Martins Creek Quarry Extension Project

REVISED PROJECT SUBMISSIONS REPORT

Submissions Report

Project Director: Barbara Crossley
Project Manager: Kirsty Davies
Report No. 3957C/R12
Date: November 2021

FIGURE 4.1

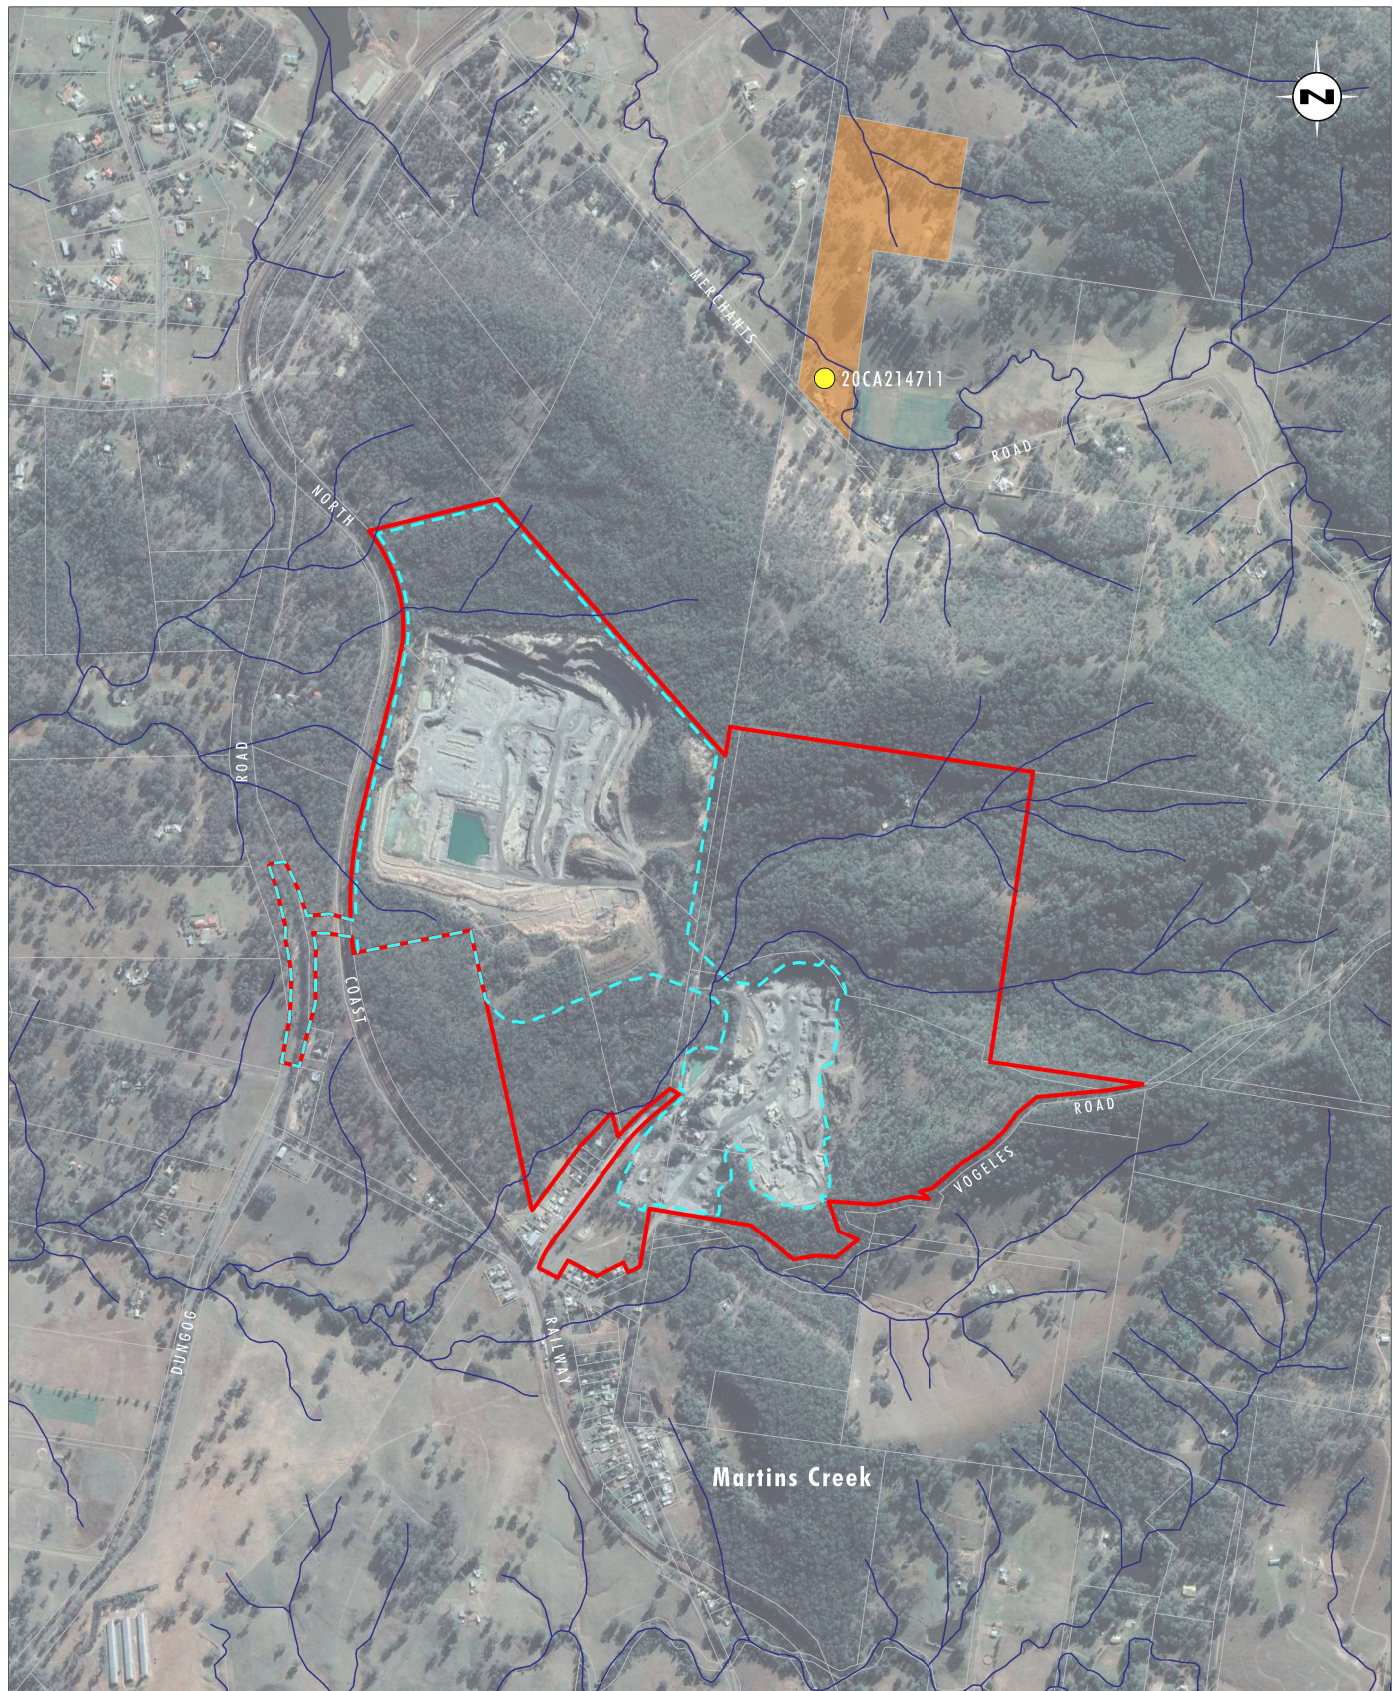
Bore 20BL171512 (converted to 20CA214711) (the bore) is located on Lot 3 DP250820 (refer to **Figure 4.1**). Upon further advice, DPIE Water informed Umwelt via email dated 14 September 2021, that the exact location of the bore cannot be confirmed, nor can it be confirmed if the bore has been constructed or in use. To undertake an assessment, AGE therefore assumed a conservative representative location of the bore as illustrated on **Figure 4.1**.

An assessment of potential impacts on the bore as a result of the Revised Project was undertaken by AGE (refer to **Appendix 7**) which concluded that there is a groundwater divide hydraulically separating the quarry from the bore. The groundwater divide is a function of the regional potentiometric surface and the hydraulic conductivity of the relevant geological units that separate the quarry from the bore (AGE, 2021a). **Figure 4.2** shows the extended conceptual model including the assumed bore location and depth.

Furthermore, the bore is not within the receiving environment of the quarry and no impacts to water quality are predicted at the property as a result of the Revised Project.

Figure 1 Barrier Insertion Cross Section

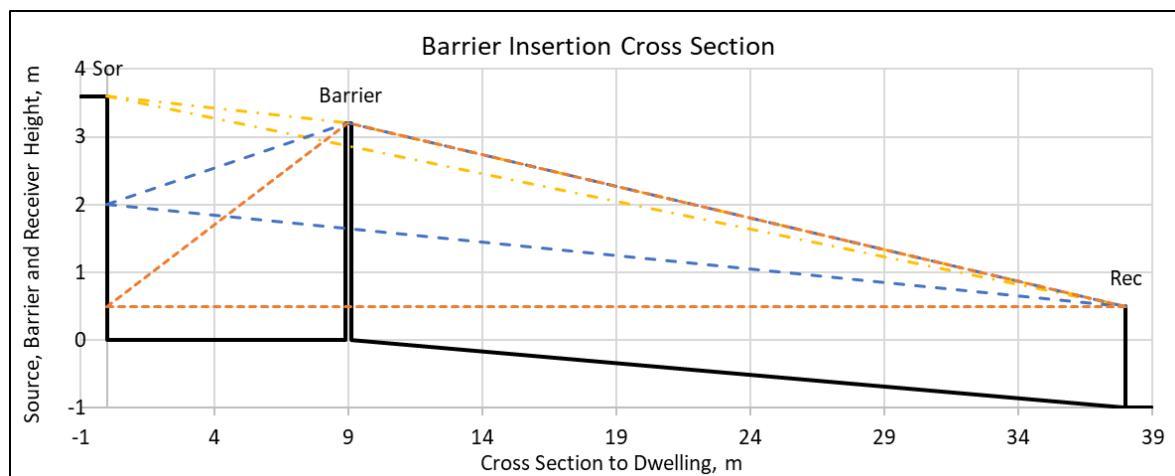
The calculation of the attenuation due to the presence of a barrier is based on the method described in CONCAWE. The noise emanating from a locomotive has been broken into three components where 50% is from the top of the locomotive (exhaust), 25% from the side of the locomotive (fans) and 25% from the bottom of the locomotive (engine). The nominated barrier height is from the top of the railhead and it is assumed the top of the locomotive is 3.6 metres above the top of the railhead. The barrier model and subsequent transmission paths from the three source locations is shown diagrammatically in **Figure 1**.

FIGURE 1

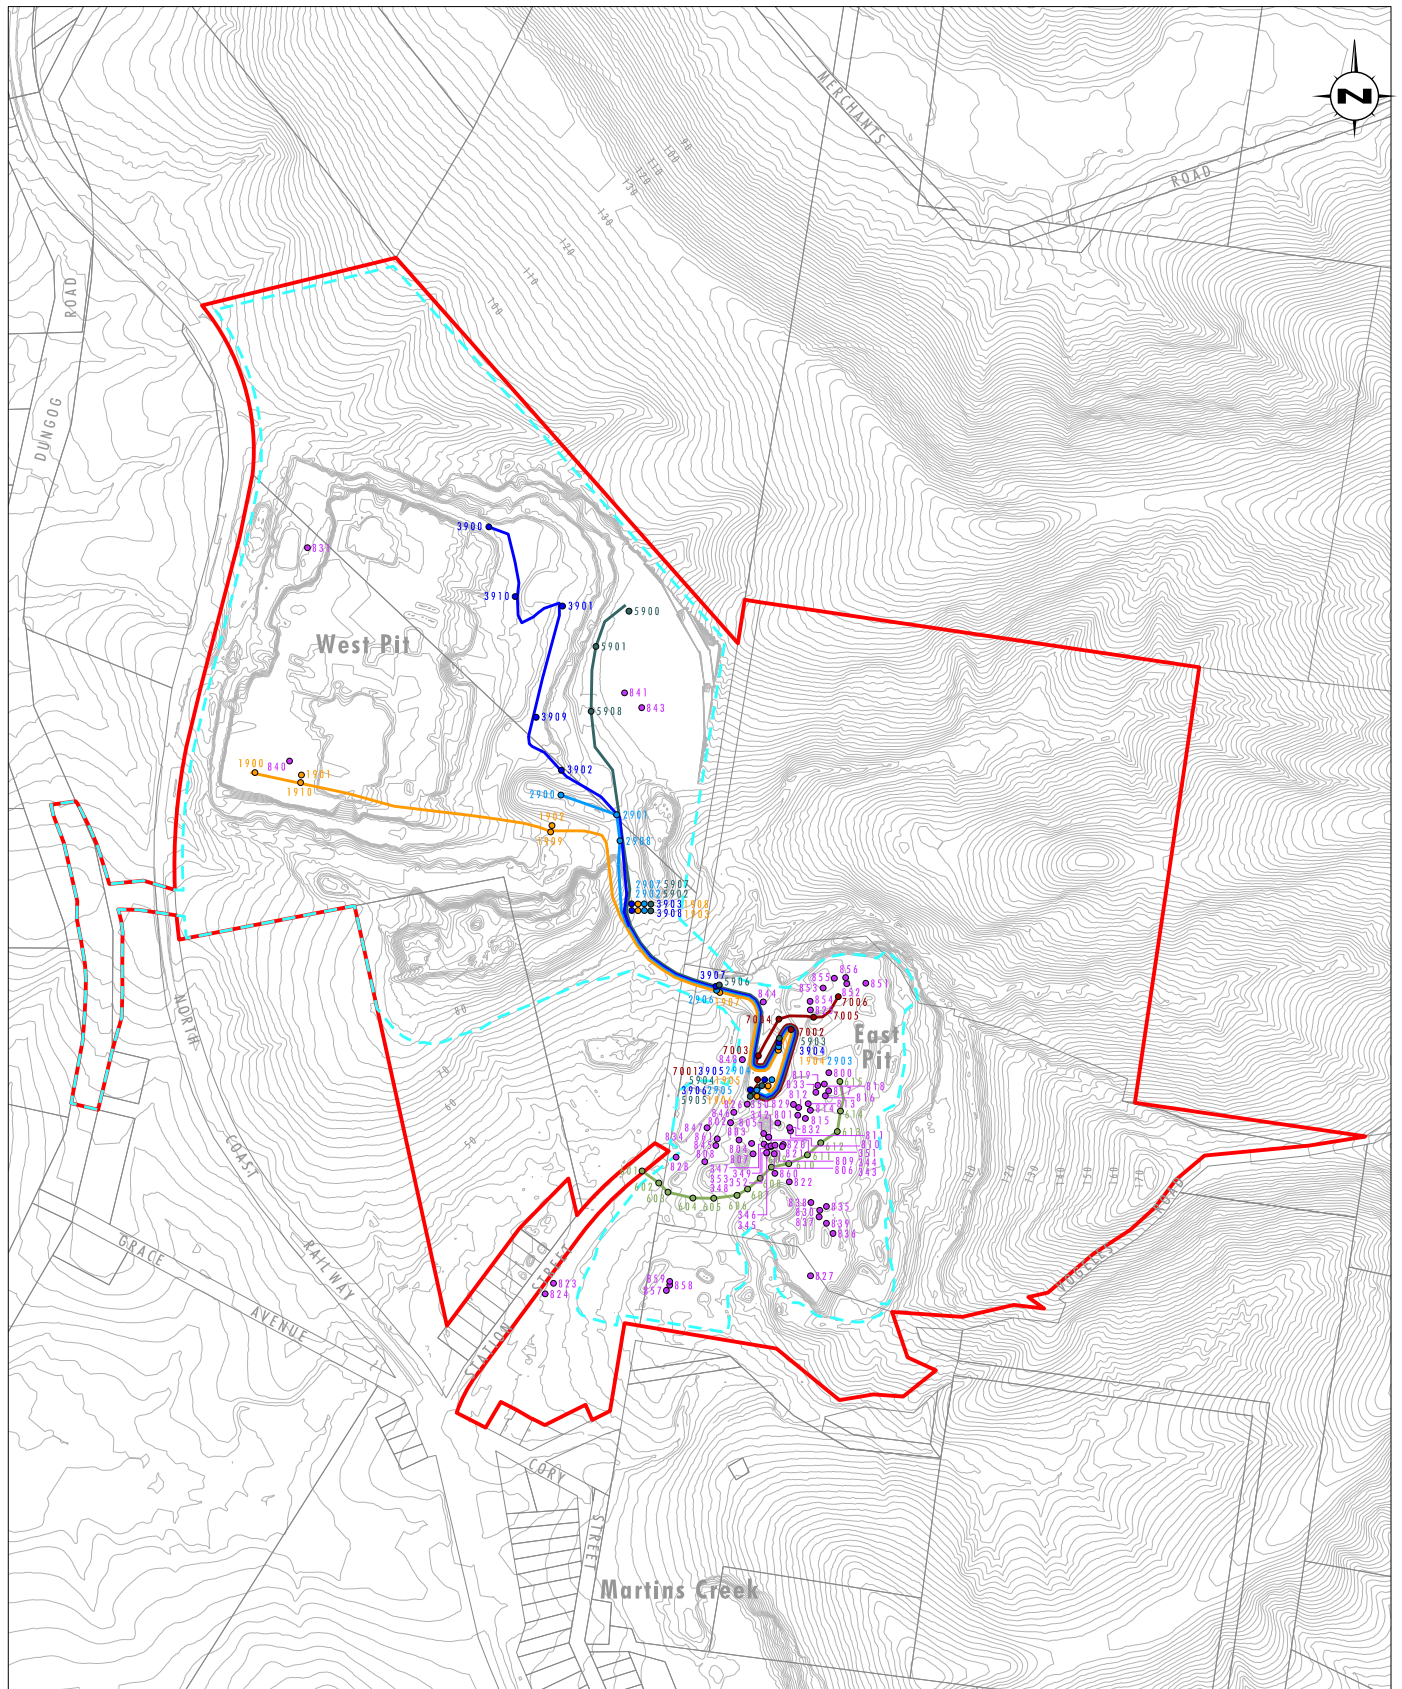
- The majority of sources in Figure A4.1 in Appendix 4 (for example the 201-203, 500-559, 1300-1309, 2300-2308, 3300-3310, 5300-5308 ranges) are not mentioned in Table A4.1. Conversely, the majority of source numbers listed in Table A4.1 are not shown in Figure A4.1;

- Haul Route 1 (sources 1300-1310) is shown in Figure A4.1 in the south-western corner of the West Pit and sources 531 and 540 are shown in the western corners of the pit, despite the description and Figure 4.2 indicating Stage 1 operations are confined to the north-eastern section of the pit; and

- In Table A4.1, sources 1900-1910 operate under calm weather conditions while sources 5900-5908 operate under adverse (wind) conditions. Presumably Haul Routes 3 (3300-3310) and 4 (5300-5308) in Figure A4.1 should correspond to these sources despite the incorrect numbering, indicating operations on high benches under calm conditions and lower elevation benches under wind conditions. This is broadly consistent with the proposed mitigation measures listed in Section 4.2, however is well outside the limited operating area of the West Pit shown in Figure 4.2.

The source item numbers on Figure A4.1 are the pre sound attenuation sources. In the modelling, these were used as the benchmark for assessing the feasible noise control options including relocation of the extraction area during noise-enhancing meteorological conditions. A revised Figure A4.1 with source item numbers updated to post sound attenuation treatment is provided on **Figure 1**.

FIGURE 2
Year 10
Noise Model
Source Locations

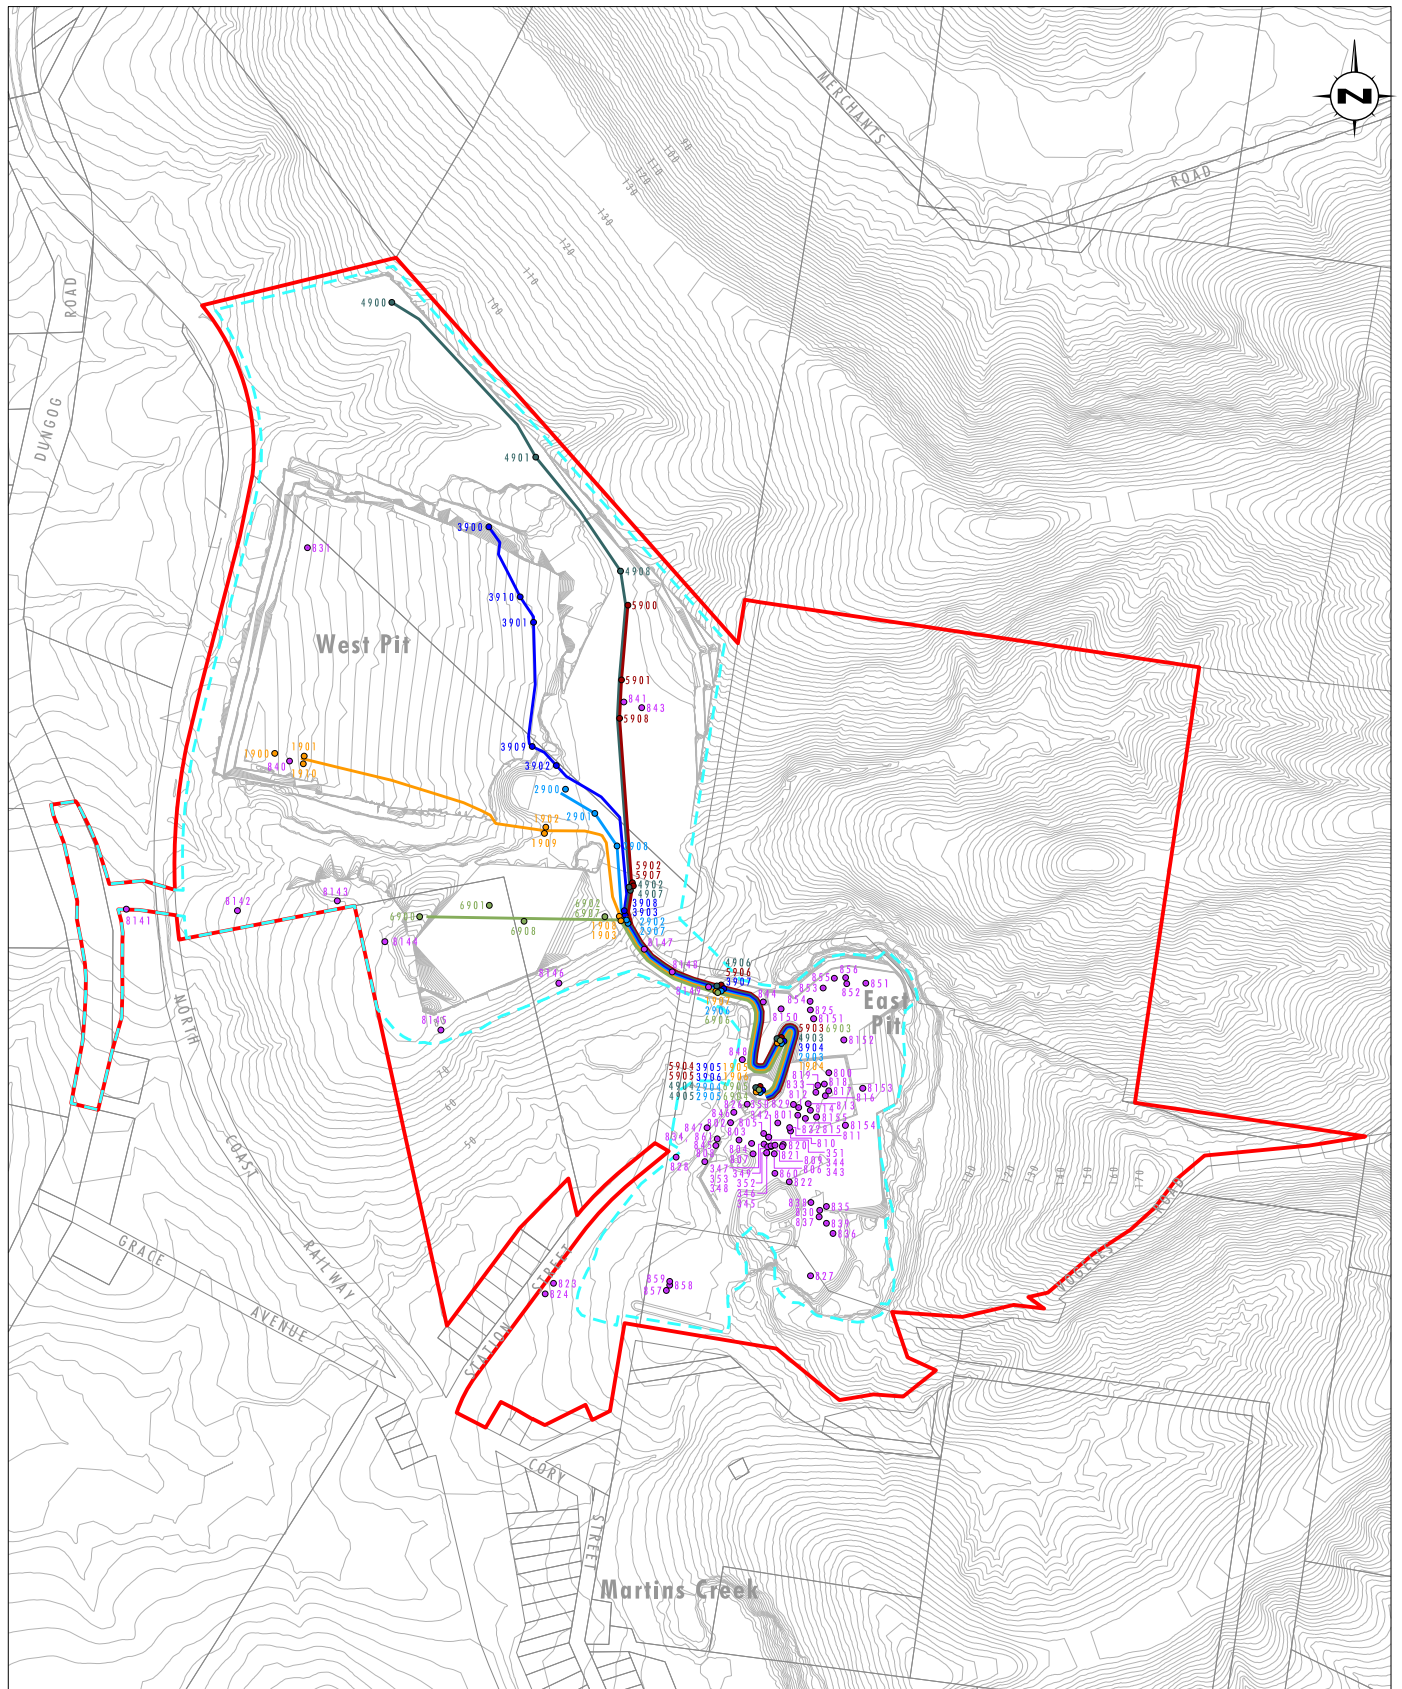
The NIA includes a description and figures showing some details of the noise model constructed to represent Stage 3, Year 10. A number of inconsistencies and apparent errors exist in the reported noise model input data. For example, Table A4.3 indicates west pit haul truck sources 2900-2908 and 6900-6908 have been modelled under calm and east wind conditions, respectively, however these sources cannot be found in Figure A4.3. This omission prevents a review of the noise model to confirm it adequately represents the proposed operations.

Sources 2900-2908 follow the 2300-2308 route. Sources 6900—6980 have been missed on Figure A4.3. The updated Figure A4.3 is provided in **Figure 2**. As outlined above, the tables and figures in Appendix 4 of the NIA are not exhaustive of every possible operational permutation that could be employed over the life of the quarry. To assess the operability of Stage 3 of the quarry, the conceptual quarry plan for Year 10 included 887 potential noise source locations and corresponding sound power levels. The modelling then included 142 operational strategies with varying degrees of physical and operational noise mitigation for 470 possible meteorological scenarios. The information presented in Appendix 4 of the NIA for Stage 3 provides representative examples of the iterative process used in the design of the Revised Project to assess the operability (or not) of the quarry during the range of meteorological conditions that could occur over the life of the quarry.
